DESCRIPTIVE REPORT
(HYDROGRAPHIC)

Type of Survey HYDROGRAPHIC
Field No. LA-10-3-76
Office No. H-9656

State OHIO & PENNSYLVANIA
General Locality SOUTH SHORE OF LAKE ERIE
Locality EAST OF CONNEAUT HARBOR

SUBJECT: Quality Control Report for H-9656 (1976), Ohio and Pennsylvania,
South Shore of Lake Erie, East of Conneaut Harbor

Velocity Table Revised during Verification

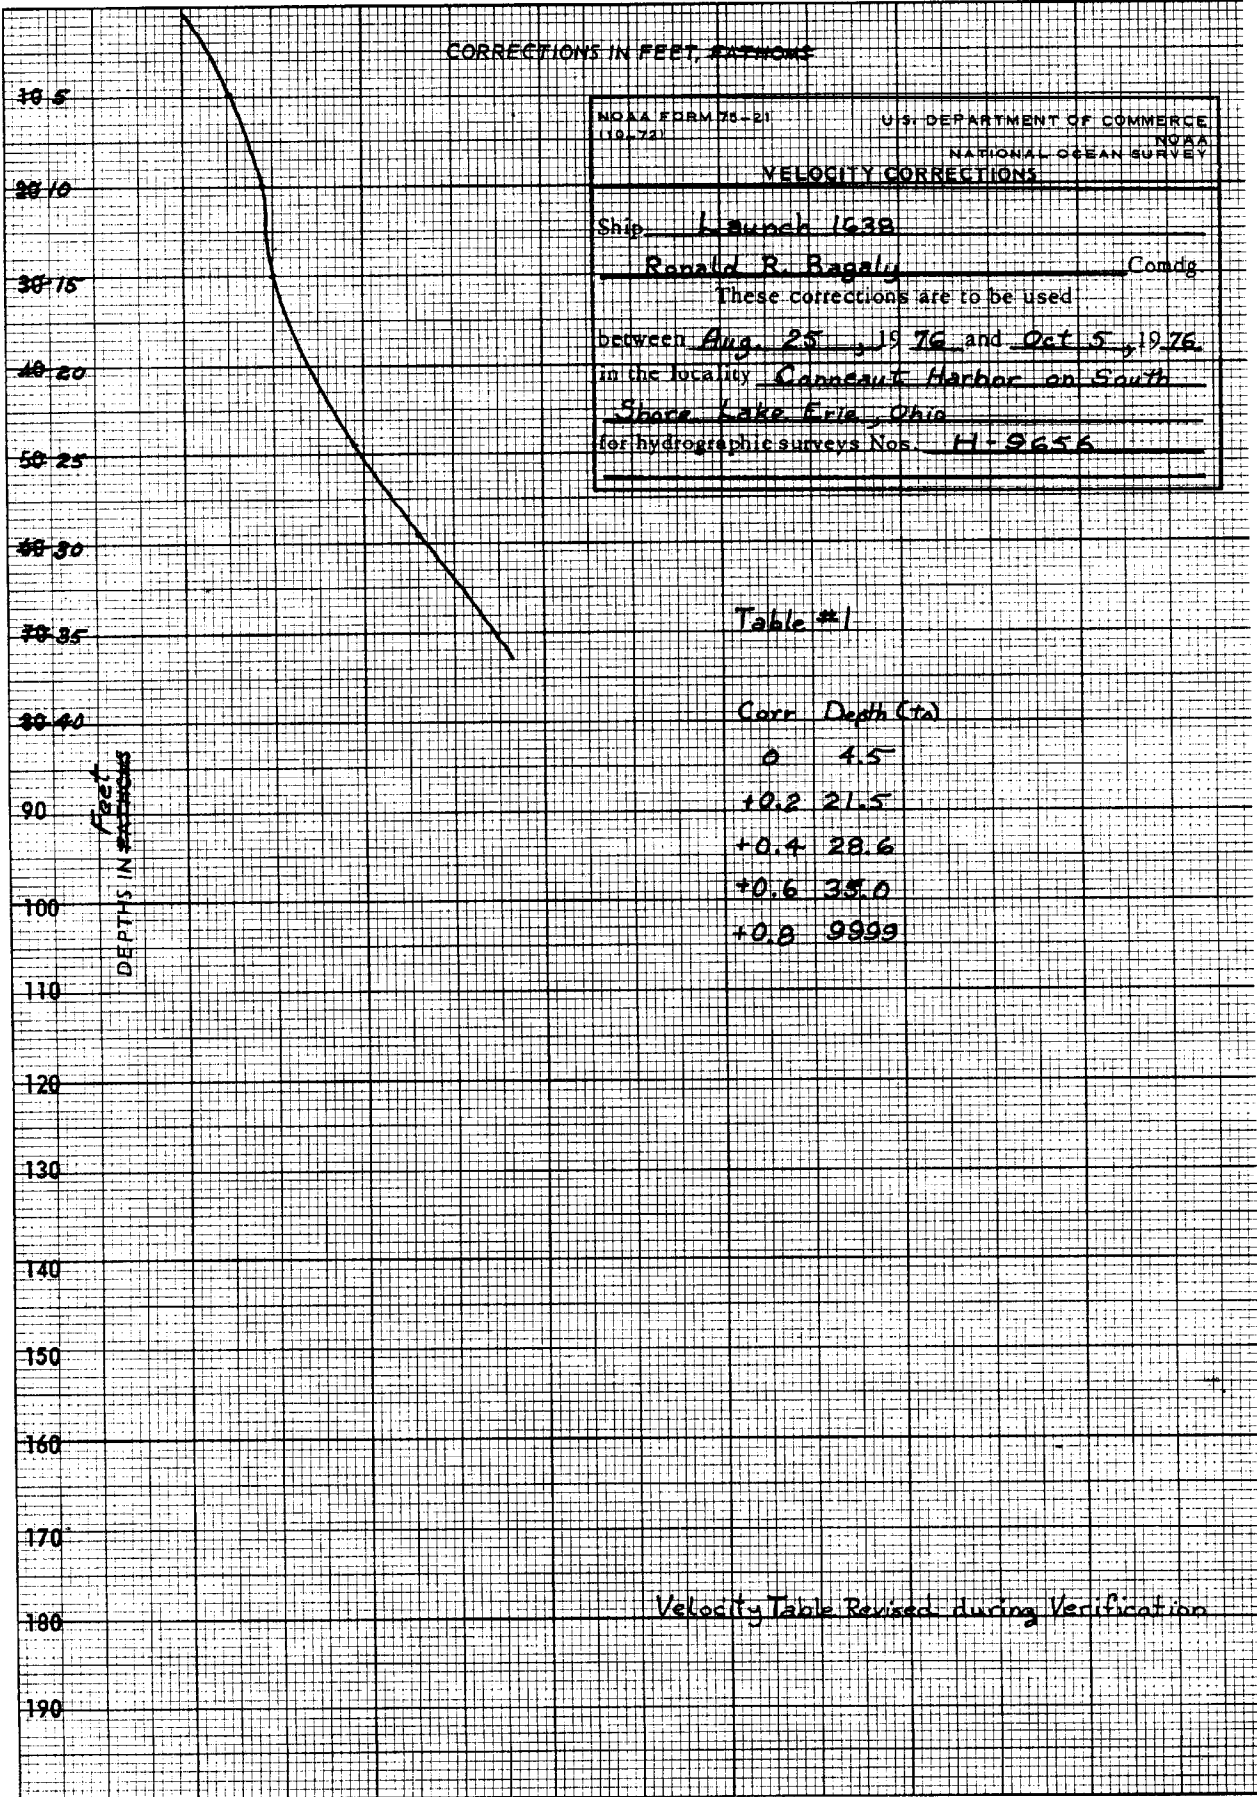
No unusual problems were encountered. Necessary changes made by the verifier to the Descriptive Report are denoted in red ink. Velocity Table Number 1 has been revised and is reflected in the new graph and table in the Descriptive Report.

Corr	Depth (ft)
0	1.5
+0.2	21.5
+0.4	28.6
+0.6	35.0
+0.8	9999
